NRL/MR/7441--94-7541

Digital Mapping, Charting, and Geodesy Analysis Program Technical Review of Vector Quantization (VQ) Decompression for the National Imagery Transmission Format Standard (NITFS)

November 30, 1994

Figure 2. VQ image data structure taken from [2].

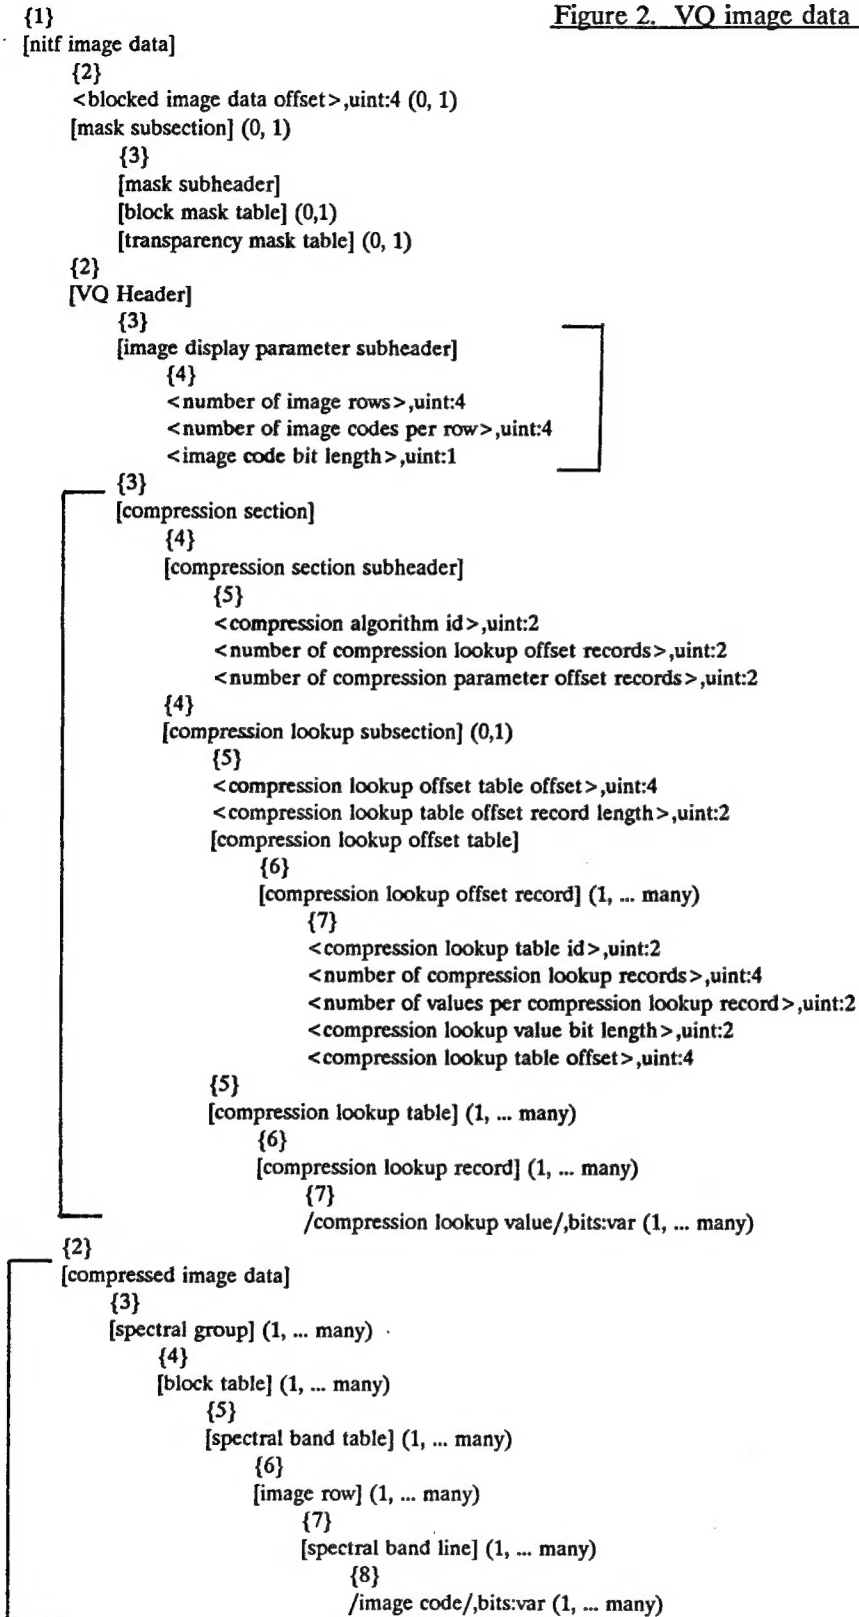
Moreover, VQ images could not be easily read by RPF compliant software, even though that *same* image formatted in the RPF could be read. This fact is evidenced by Figures 1 to 4, where similar sections between the figures are marked for easy association. Figure 1 details an RPF frame file and Figure 2 shows the VQ file structure. Although both are similar to the NITF (Figures 3 and 4), obvious differences exist. DMAP recommends the following additions/changes to the VQ standard's [NITF image] (Figure 7 on page 13 of [2]) for at least minimal agreement with the RPF's [frame file]:

These figures also show some minor differences that, once changed, could make the parallel sections correspond more closely. For instance, in Figure 1, the name [*subframe* table] is used at a structural level where the name [*block* table] appears in figure 2. Do these names and locations imply that a *subframe* in RPF corresponds to a *block* in a VQ image? If so, then the correspondence should be clarified in the RPF or VQ standard.

- i. Add a tagged [color/grayscale section] to the image subheader;
- ii. Add a [compression parameters section] to house the [image display parameter subheader];

- iii. Increase the [compression section] to level {2}. Note: in the RPF [frame file], the [compression section] is on the same level as [image section].

Figure 4. NITF file structure taken from [1].

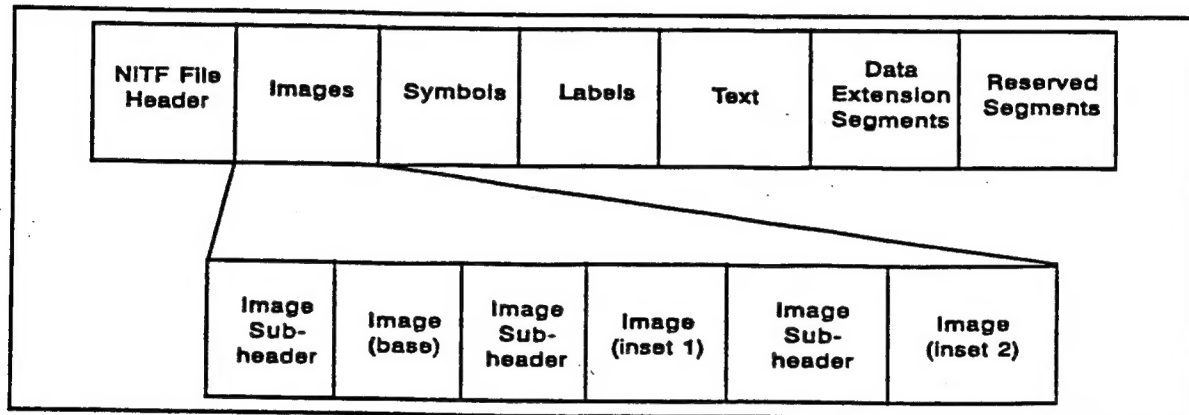
20. P 6 F 2 For completeness, this figure should include (but not emphasize) the information in figure 4 of this review, which shows other NITF sections such as the symbol section and label section.
